## HISTORIC AND DESIGN REVIEW COMMISSION

**HDRC CASE NO:** 2019-117  
**ADDRESS:** 434 SHERMAN ST  
**LEGAL DESCRIPTION:** NCB 514 BLK 18 LOT E 75 FT OF 13  
**ZONING:** R-6, H  
**CITY COUNCIL DIST.:** 2  
**DISTRICT:** Dignowity Hill Historic District  
**APPLICANT:** Alvin Peters  
**OWNER:** Waseem Ali, Stephanie Zarriello  
**TYPE OF WORK:** Construction of a 2-story, single-family residential structure  
**APPLICATION RECEIVED:** February 27, 2019  
**60-DAY REVIEW:** April 28, 2019 (Referred to DRC and postponed by applicant)  
**CASE MANAGER:** Edward Hall  
**REQUEST:**

The applicant is requesting conceptual approval to construct a two story, single family residential structure on the lot at 434 Sherman Street, located at the corner of Sherman and N Olive, within the Dignowity Hill Historic District.

SHEET  
SANBORN GOOGLE  
**A1.2**

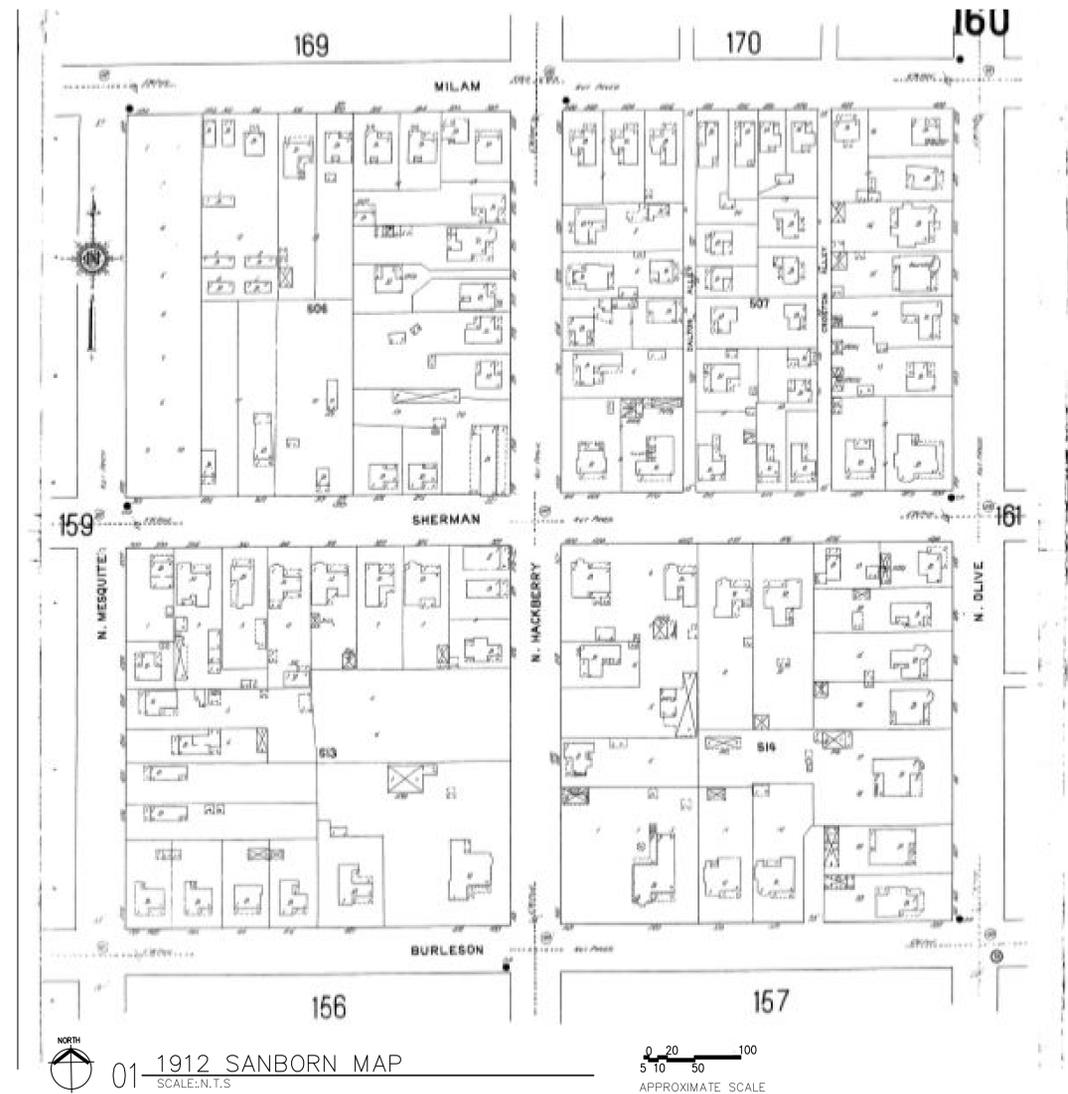
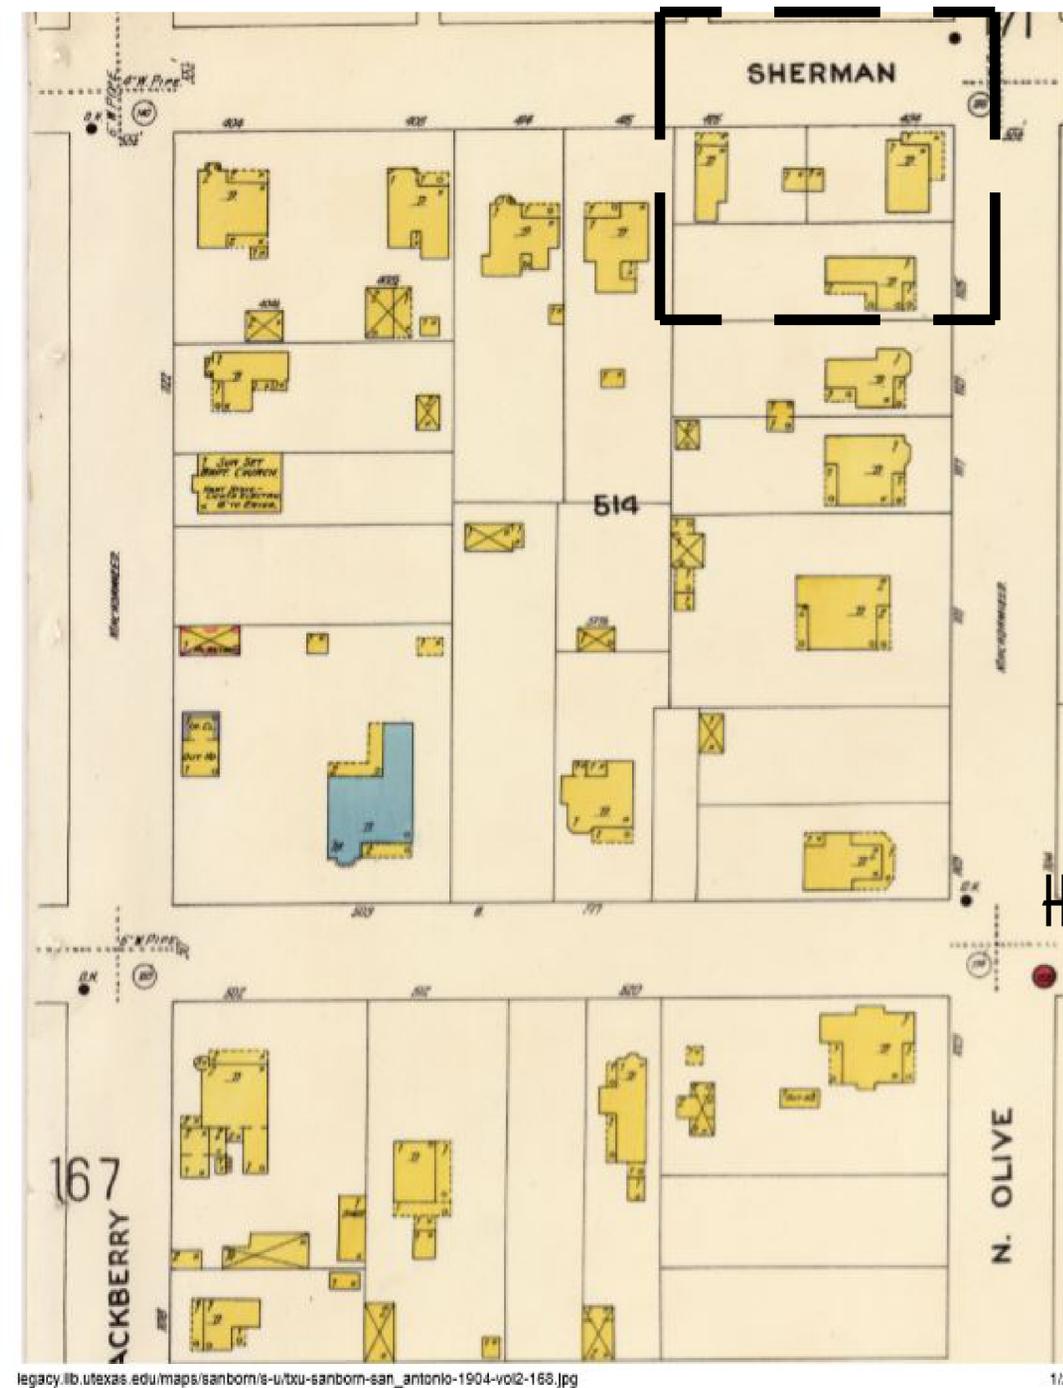
- i. **SETBACKS & ORIENTATION** – According to the Guidelines for New Construction, the front facades of new buildings are to align with front facades of adjacent buildings where a consistent setback has been established along the street frontage. Additionally, the orientation of new construction should be consistent with the historic examples found on the block. The applicant has proposed a front setback that is less than those found historically on the block. While there may have been a historic structure with a shallow setback on this lot, staff finds that new construction should feature a greater setback than the historic structures on the block.

Olive and Sherman Streets. (Refer to Sanborn Maps and Google Photos on Sheet A1.2) We are Proposing a Front Setback of 13' which complies with the current Zoning Front Setback requirement of 10'.

*The residence at 434 Sherman was 5'-7' from the Olive street property line, as indicated by the Sanborne maps and Google images.*

ROOF PLAN  
A4.1

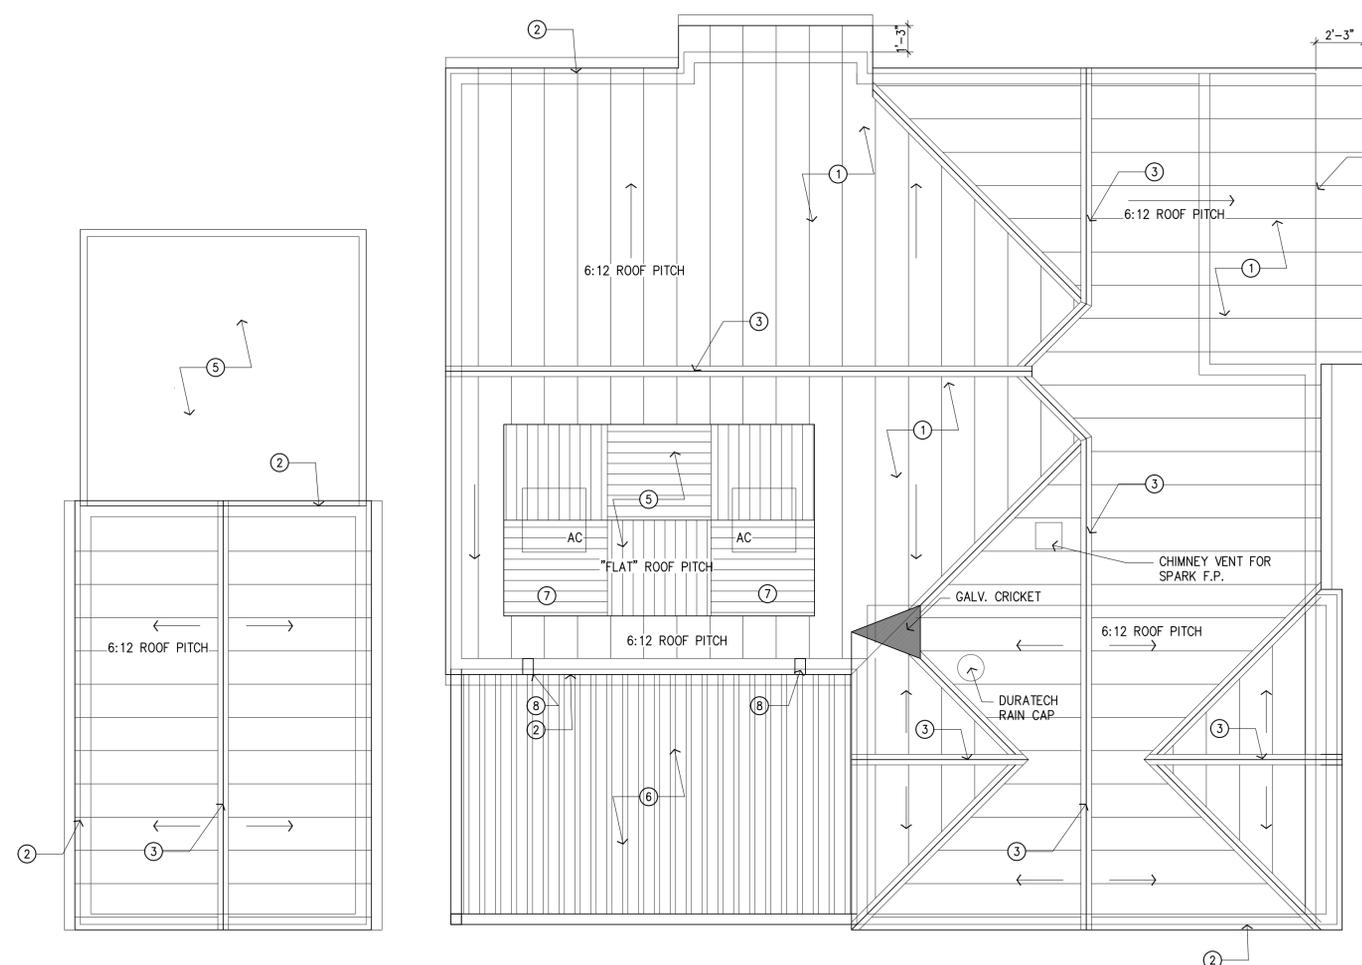
- n. **ROOF FORM** – The applicant has proposed a number of roof forms for the proposed new construction, including hipped and gabled roofs of various proportions and profiles. Historic structures on both Sherman and N Olive feature front facing gabled roofs with other forms including hipped and shed porch roofs. Staff finds that a simplified roof form with consistent ridge heights would be more complementary of those found historically in the district.

- s. ARCHITECTURAL DETAILS (ROOF) – The Guidelines for New Construction 4.A.ii. notes that architectural details should be based on those found traditionally within the district. Staff finds the proposed roof forms to be contemporary in nature and inconsistent with both the historic development pattern found in the district as well as the Guidelines.

MB: REVIEW ROOF PLAN.

- j. We Concur and have redesigned the roof form to a more traditional Gable and Hip design as suggested by Jeff Fetzer FAIA.
- k. We Concur, We have reduced the building foot print to 48.1%.

- l. We Concur, See revised sheets A4.1 A5.1 and A5.2.
- m. We Concur, See Wood Window Details A5.1.
- n. We Concur and have redesigned the roof form to a more traditional Gable and Hip design as suggested by Jeff Fetzer FAIA.

ELEVATIONS

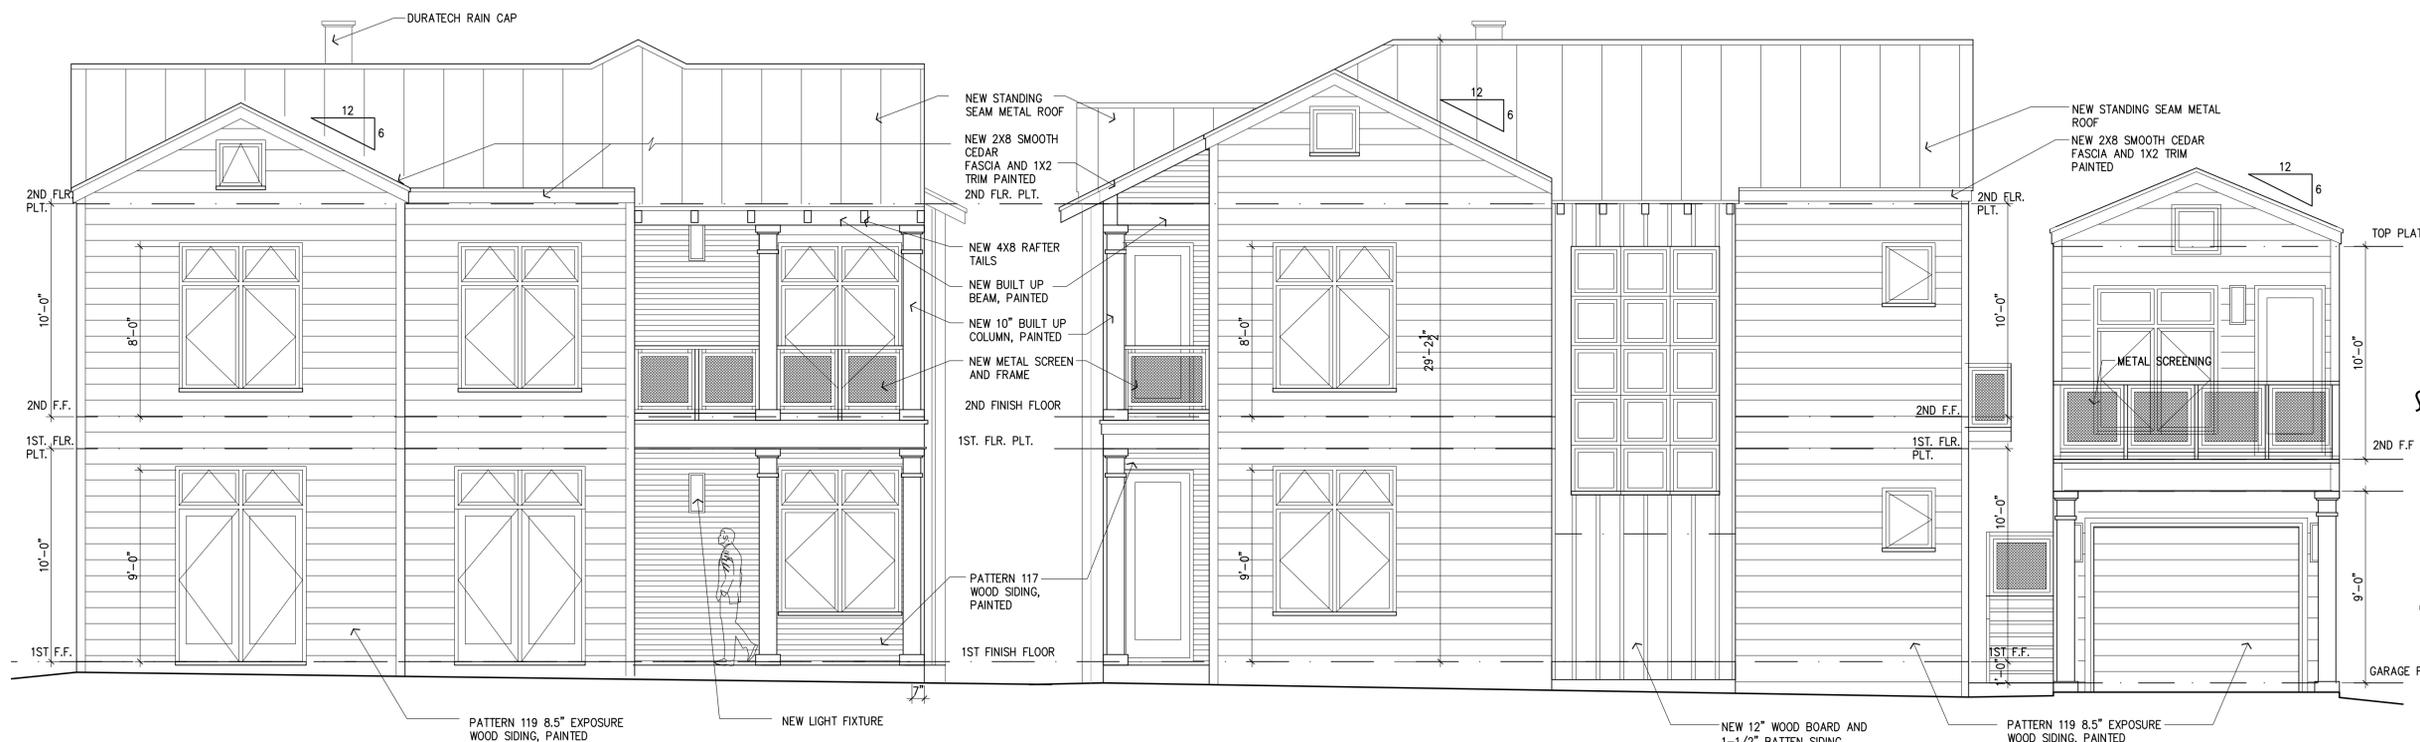
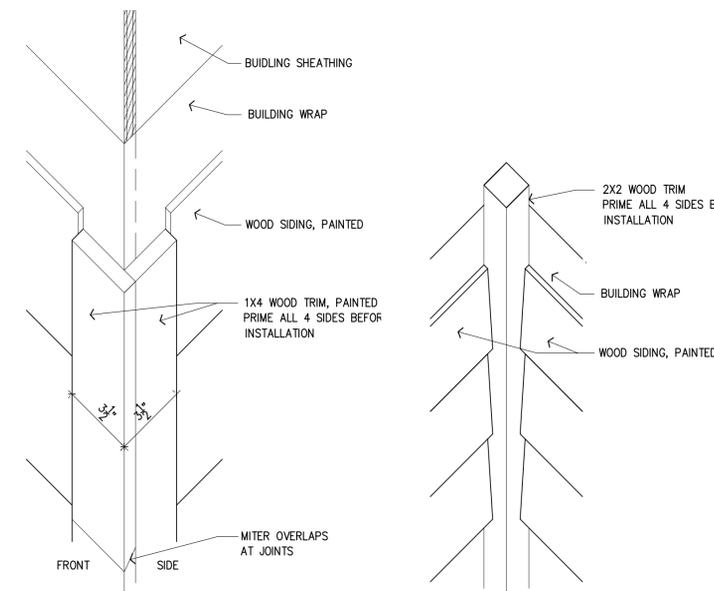
- l. **SCALE & MASS** – Per the Guidelines for New Construction 2.A.i., a height and massing similar to historic structures in the vicinity of the proposed new construction should be used. In residential districts, the height and scale of new construction should not exceed that of the majority of historic buildings by more than one-story. These blocks of Sherman and N Olive feature one story historic structures. The applicant has provided as a massing diagram of both Sherman and N Olive noting a grade change on Sherman. While the elevation change notes an overall height that is subordinate to that of the structures on the southern end of this block of N Olive, the proposed new construction is approximately twelve (12) feet taller than the adjacent, historic structure.

- r. FENESTRATION PROFILE – The applicant has proposed a number of windows that feature profiles that are not consistent with those found historically in the district. These profiles include fixed picture windows, windows that do not feature sashes and windows that are contemporary in profile and location. Staff finds that the proposed fenestration patterns should be modified.

**COMMENTS/CONCERNS:** RA: OVERVIEW OF DESIGN UPDATES. RA: DISCUSSION ON PROPOSED FRONT SETBACK (13 FEET), RA: LOT IS ONLY 75 FEET DEEP, MOST ARE 150 FEET DEEP, 48.1% LOT COVERAGE, SC+JF: VARIOUS QUESTIONS ABOUT MODIFIED DESIGN. JF: DESIGN NOW ADDRESSES BOTH SHERMAN AND OLIVE, JF: QUESTIONS REGARDING WINDOW PROFILES, SC: EXPOSURE ON SIDING? RA: JELAWEN WOOD WINDOWS PROPOSED, JF: CONSIDER OVERHANG AT GABLE ENDS RATHER THAN FLUSH ENDS.
